CITY OF FORT PIERCE TECHNICAL REVIEW COMMITTEE

Minor Site Plan Amendment - PNC Bank - 500 Virginia Avenue

RE: **Technical Review Project- PNC minor site plan amendment- 22-41200002**
500 Virginia Avenue
PCN: 2415-343-0001-000-1 and 2415-344-0005-000-2

The following is a response to staff comments. Below are the comments along with our responses in bold:

SHEET TITLE:
LANDSCAPE PLAN & PLANTING SCHEDULE
 SHEET NUMBER:
L-2.0

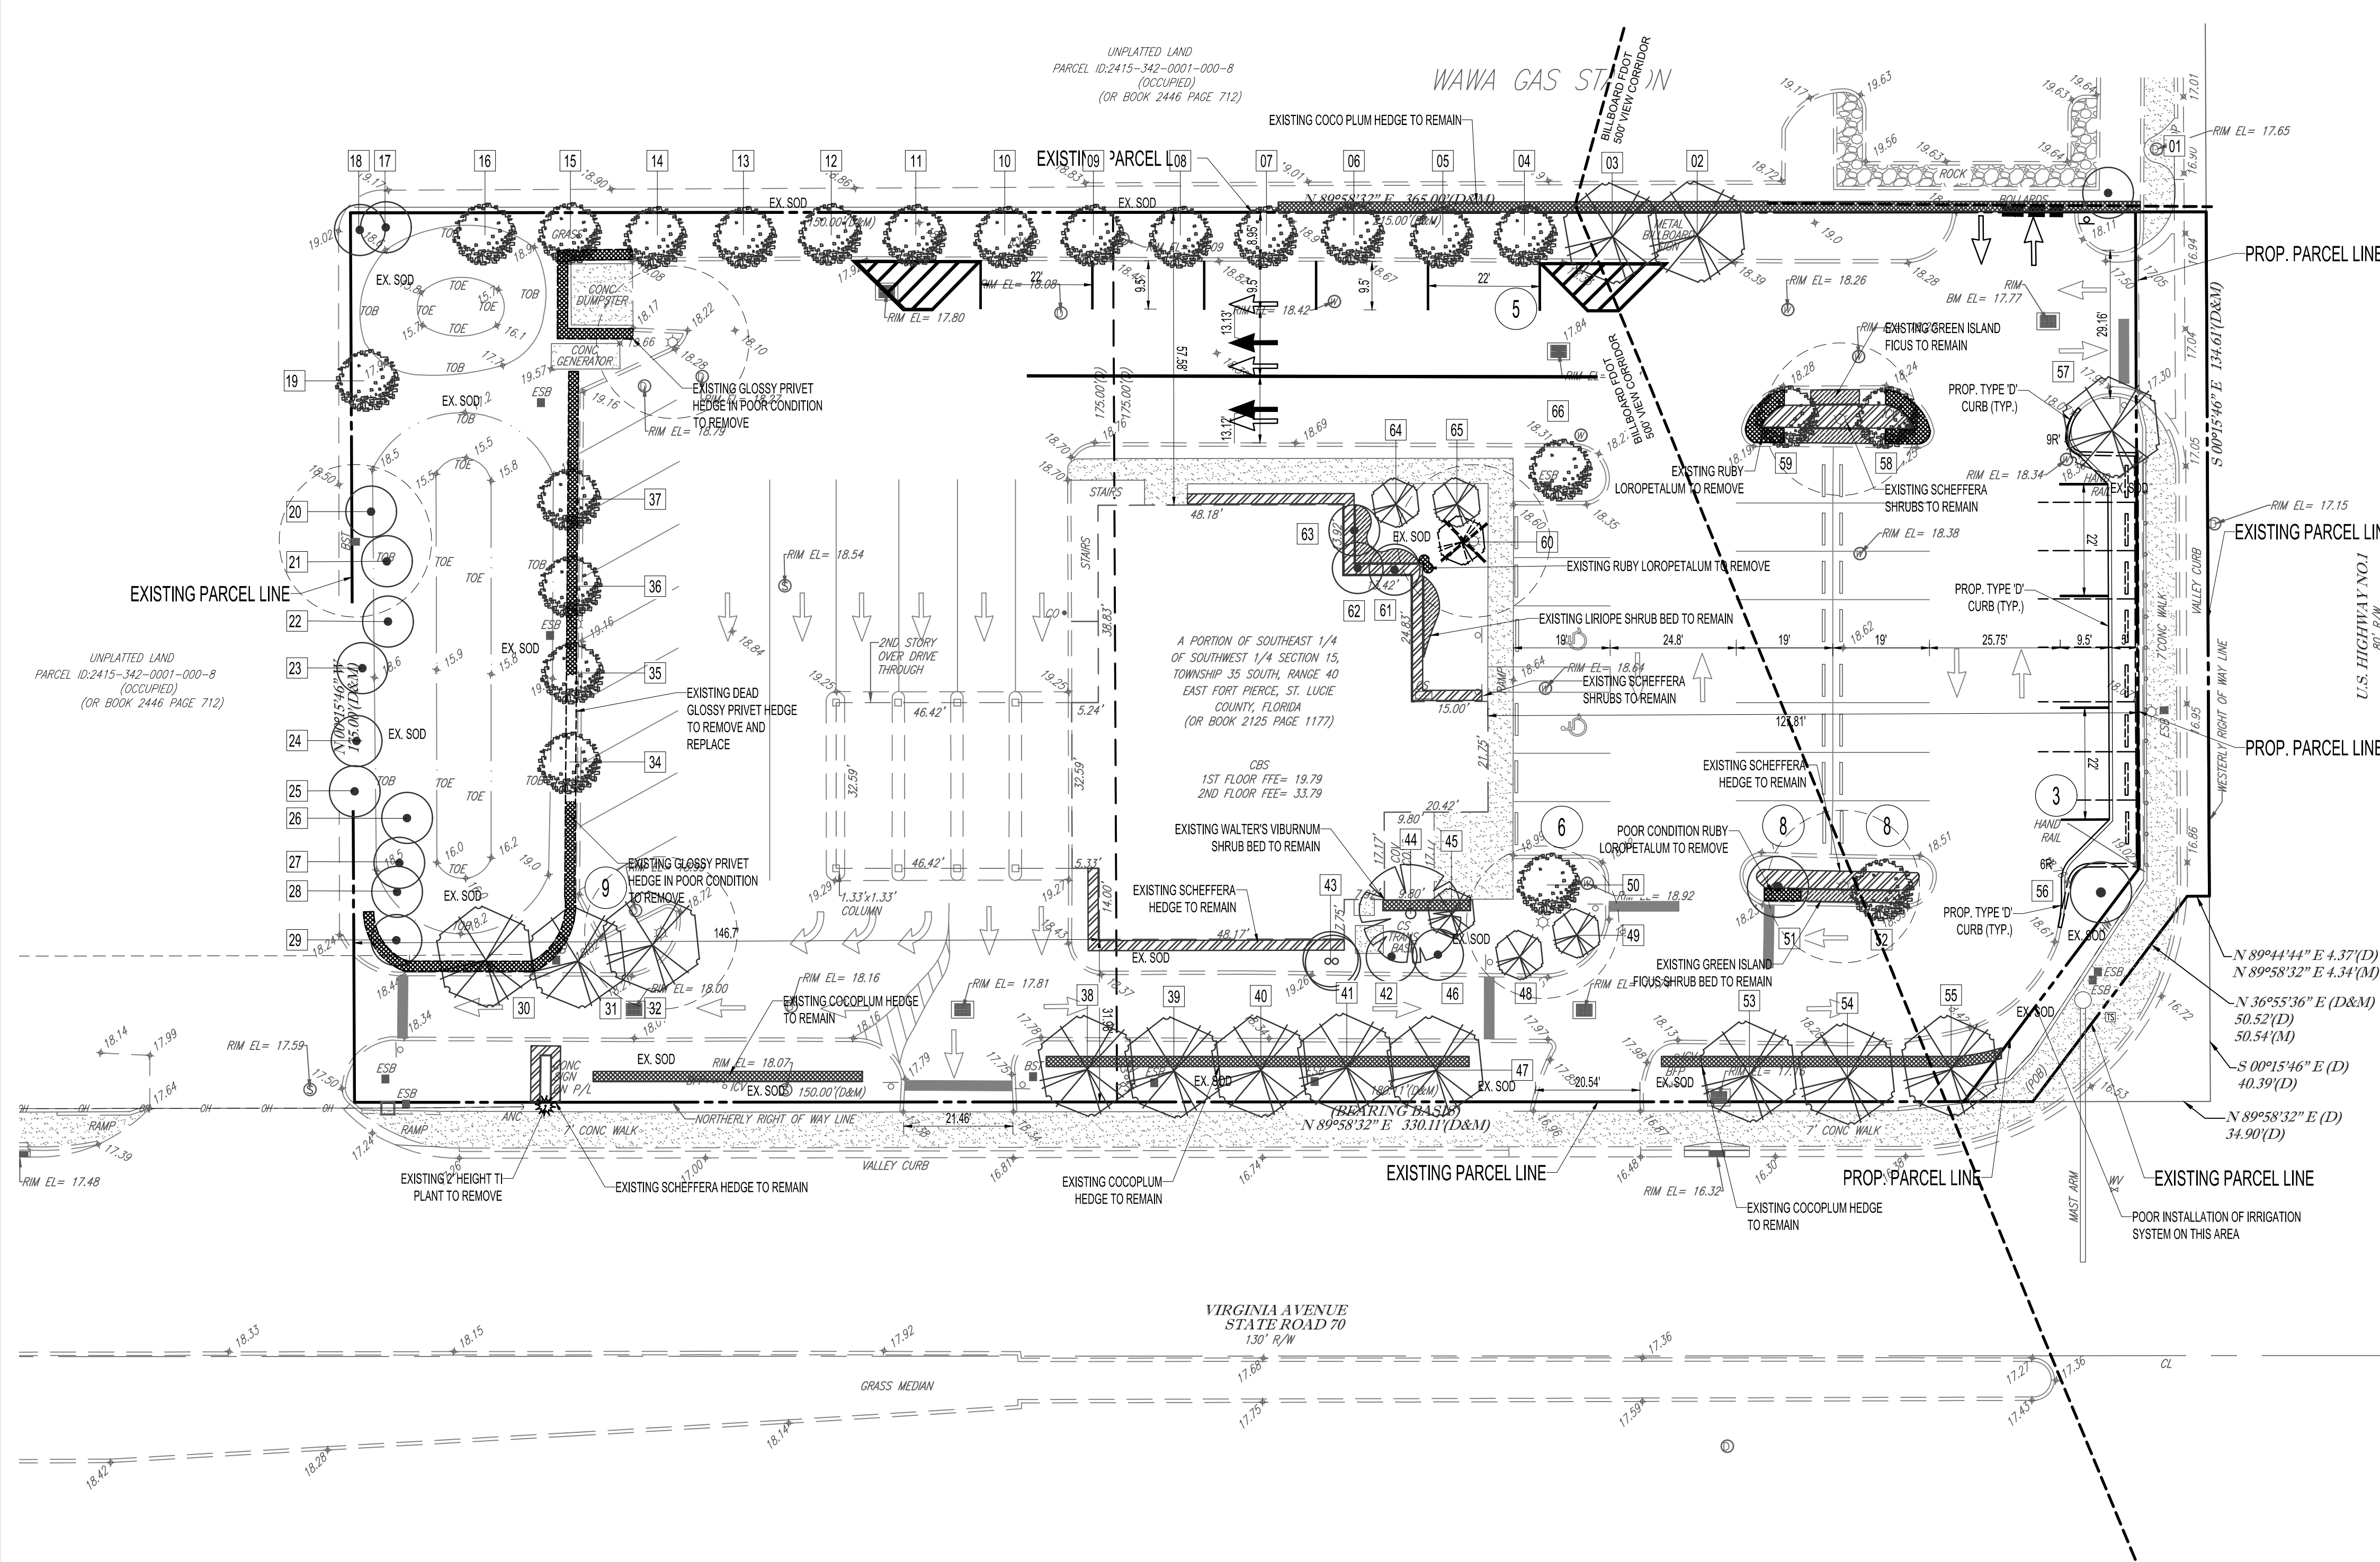
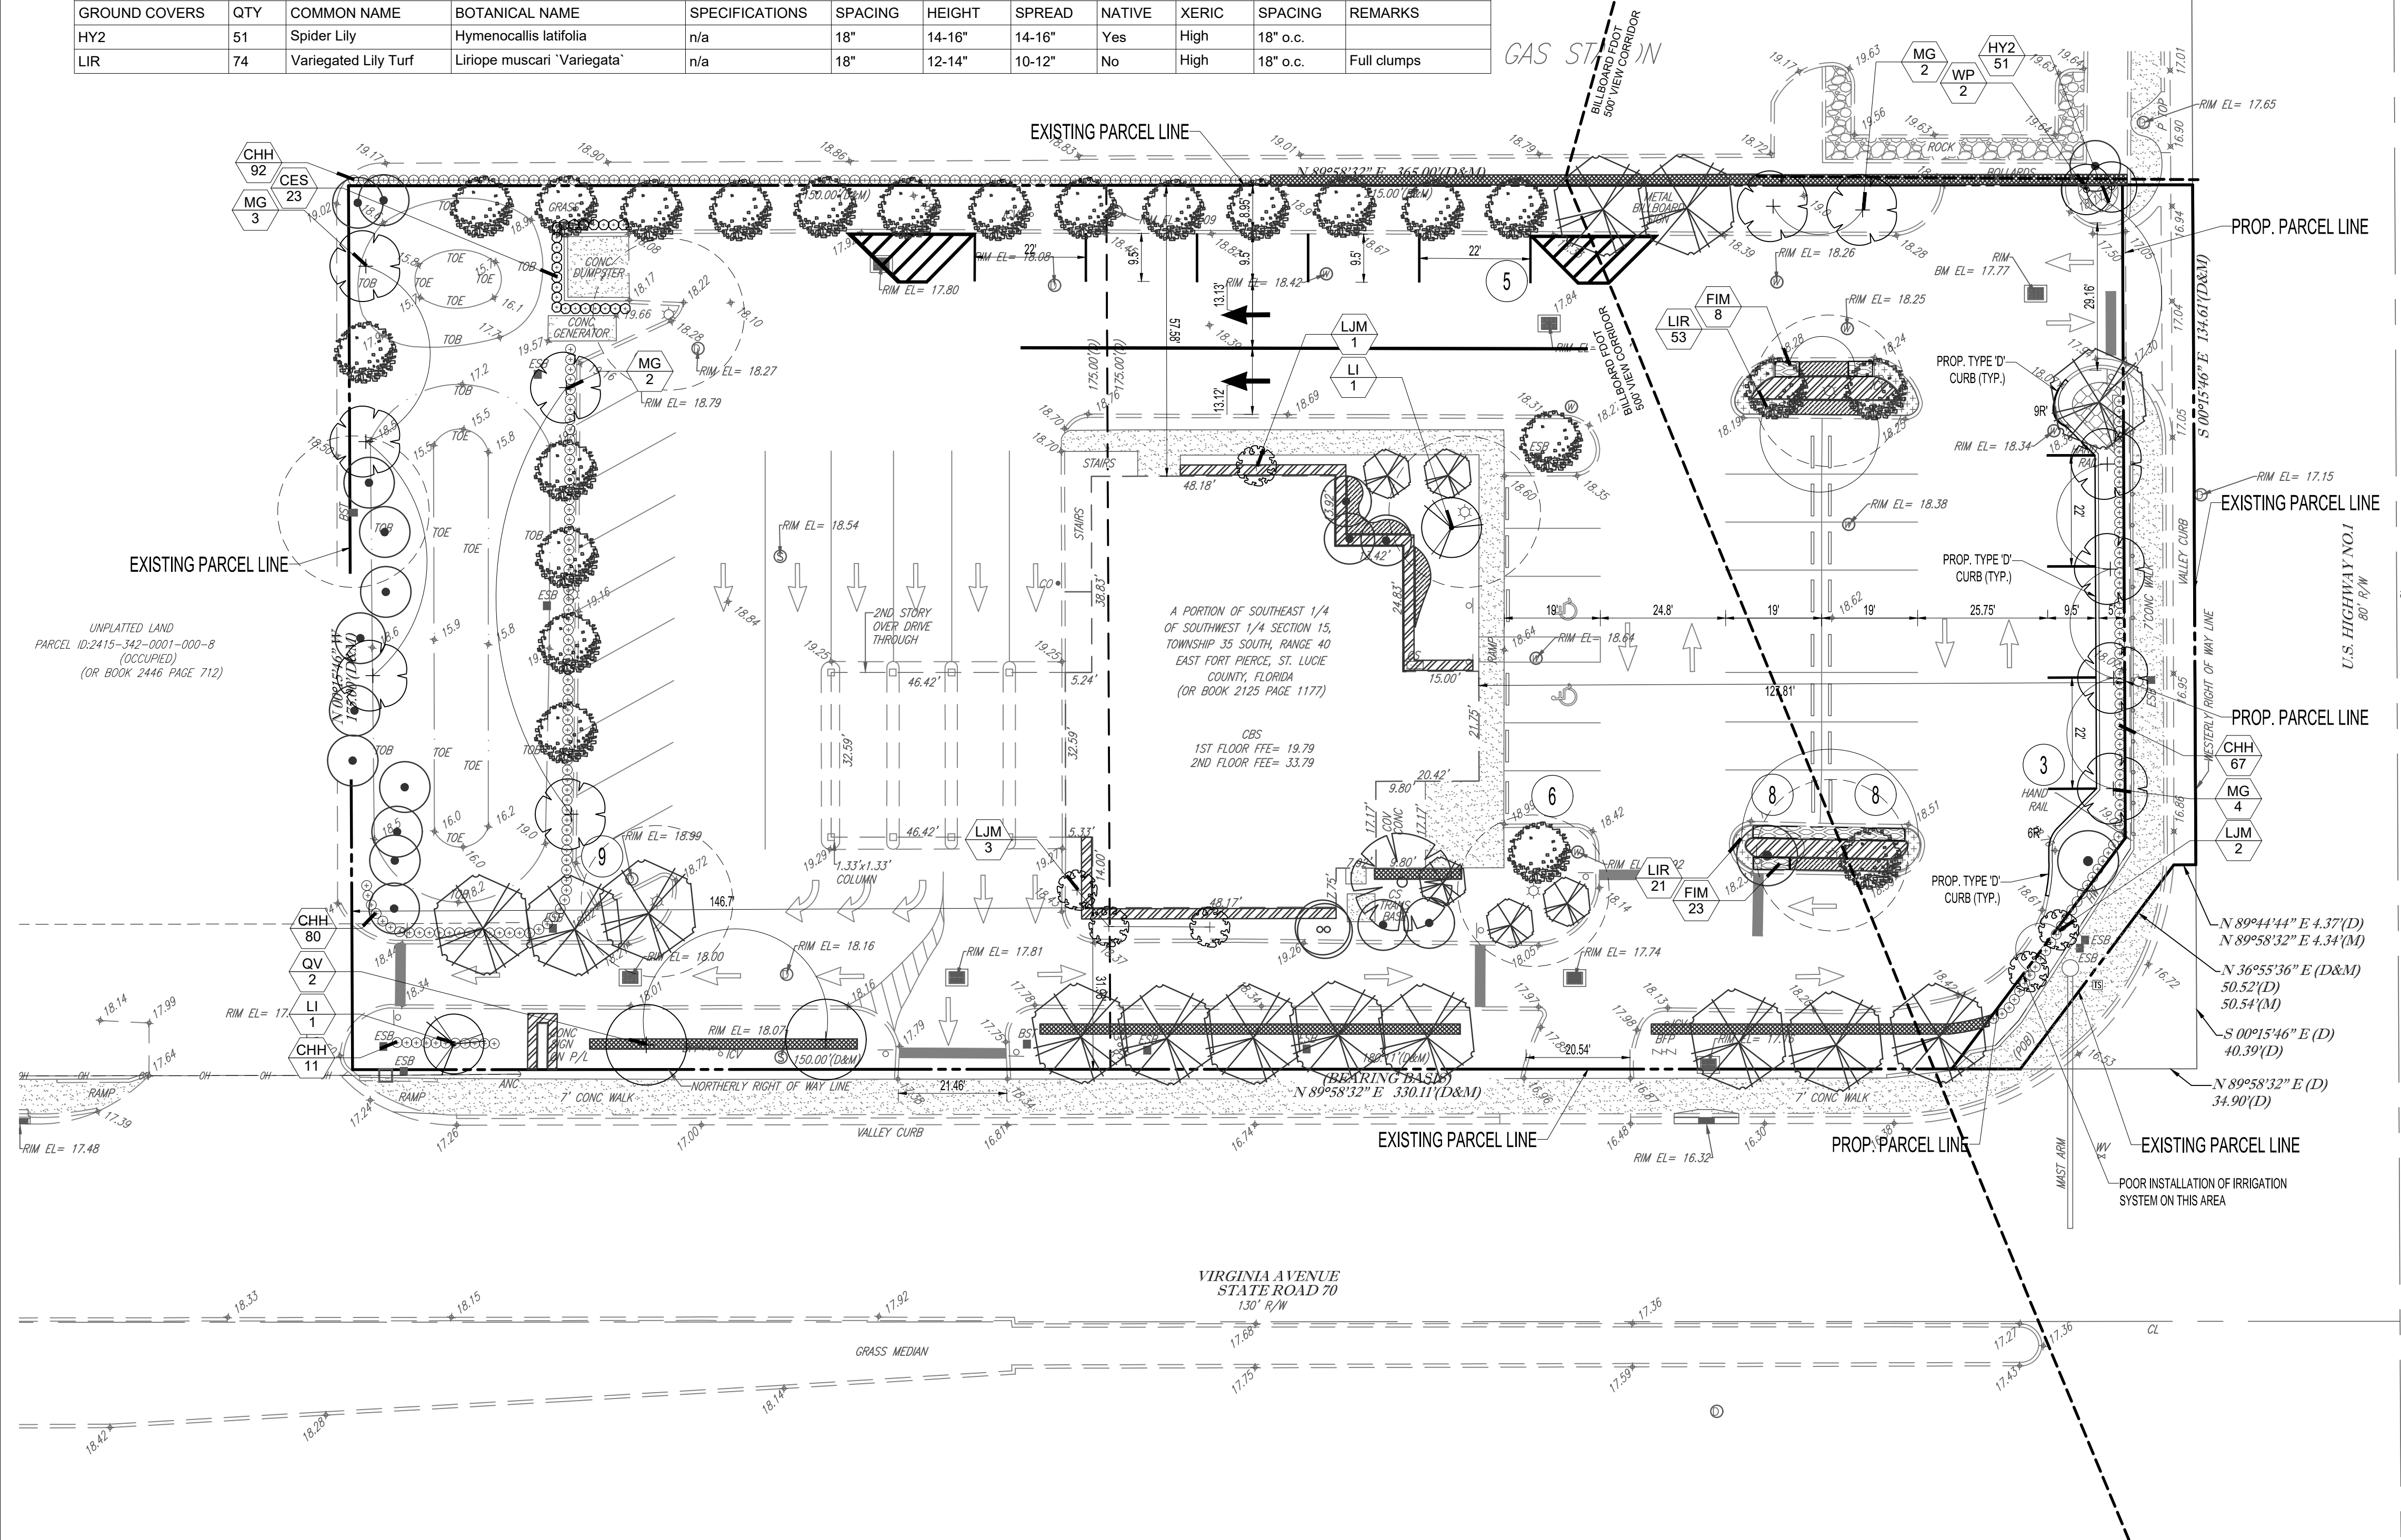
1. A Landscape Plan shall be provided at the time of Application that is signed and sealed by a Florida Registered Landscape Architect pursuant to City Code 123-37, General Landscaping requirements. The Landscape Plan shall include both interior and exterior landscaping.

Response: Landscape Plans have been provided as part of this submission. Please refer to Landscape Sheets, L-1.0, L-1.1, L-2.0, L-2.1, and L-2.2.
